UNITED STATES PATENT AND TRADEMARK OFFICE

Office Action Summary

10/683,616

FERNANDEZ, JOYCE

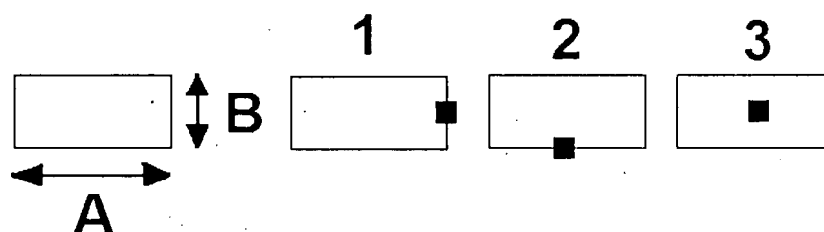
Regarding claims 13 and 14, the pocket (37) of either Hathaway sling is in a branch of the sling that would not be directly entangled in a knot formed therein, and is thus considered by Examiner to be beyond the knot, effectively satisfying the limitations of the claim. Regarding the pocket being used to hold child-care things, the initial statement of intended use and all other functional implications of the pocket have been carefully considered but are deemed not to impose any patentably distinguishing

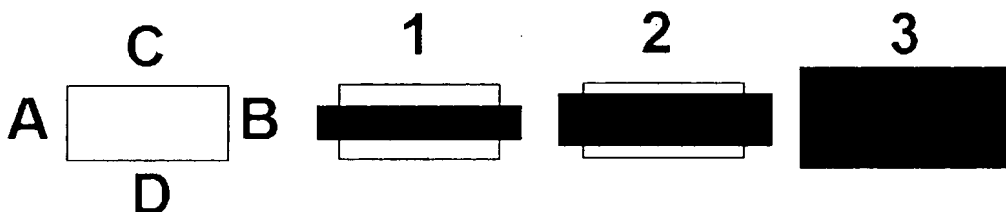
Applicant's attention to Figures 1 and 2 of Hathaway. Examiner is of the position that these Figures clearly show the sling (portion 70) extending completely over/under or covering completely the buttocks of the child being held therein. The width of this portion (70) is found throughout the length of the sling as seen in Figure 3. Furthermore, because children's buttocks can be any number of sizes, it follows that any number of slings can be considered to have widths that would cover some child's buttocks. To simply state that Hathaway does not disclose such a width is to say that there is no child anywhere in the world with a bottom that could be covered by the sling branches of Hathaway. Finally, the boxes below help illustrate Examiner's position that the sling branches of Hathaway are of a width to cover a child's buttocks. The leftmost box is shown to have four sides, A, B, C, and D. Figure 1 shows a box with a black strip covering the box completely in a direction from side A to side B, and partially in a direction from side C to side D. Figure 2 shows a box with a black strip covering the box completely in a direction from side A to side B, the strip covering more of the box in a direction from side C to side C than did the strip of Figure 1. Figure 3 shows a box covered by a black strip in both directions from side A to side B and from side C to side D. Examiner is associating the sling branches of Hathaway with the black strip of Figure 1, while Applicant is intending the limitations of the claims to explicitly define a width such as that of the black strip in Figure 3.
